## **CARRACELA SUBDIVISION**

APPLICATION NUMBER 8 DATE July 21, 2005

APPLICANT Carracela Subdivision

REQUEST Subdivision

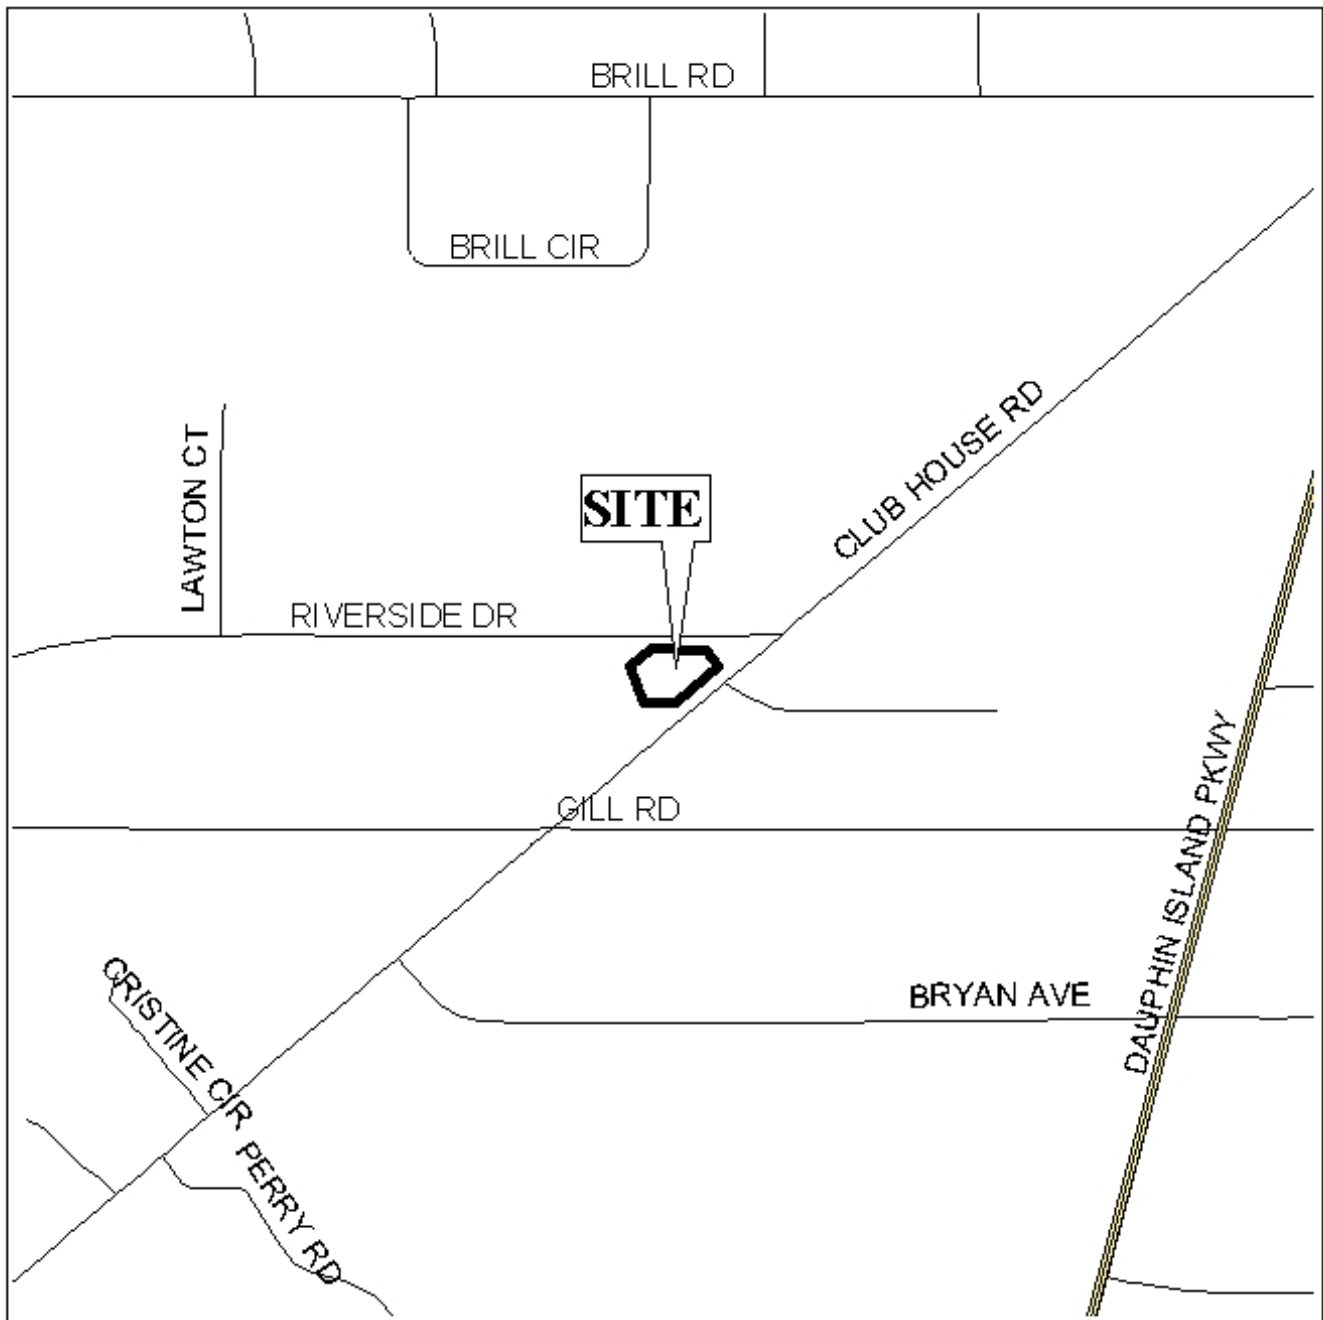
The site fronts Riverside Drive, which has a 60' right-of-way, and Club House Road, which has a substandard width right-of-way of 40'; thus dedication of sufficient right-of-way to provide 25' from the centerline of Club House Road should be required. The 25' building setback line, depicted on the plat, should be revised to reflect 25' as measured from the dedication.

A note should be required on the final plat stating that the site is limited to the existing curb cuts.

The present nonconforming use as a convenience store/service station has been documented and approved; thus, a buffer should be required between the site and adjoining residential properties, in compliance with Section V.A.7 of the Subdivision Regulations.

The plat meets the minimum requirements of the Subdivision Regulations and is recommended for Tentative Approval, subject to the following conditions: 1) the dedication of sufficient right-of-way to provide 25' from the centerline of Club House Road, with adjustment of the 25' building setback line to reflect the dedication; 2) the placement of a note on the final plat stating that the site is limited to existing curb cuts; and 3) the provision of a buffer between the site and adjoining residential properties, in compliance with Section V.A.7 of the Subdivision Regulations.
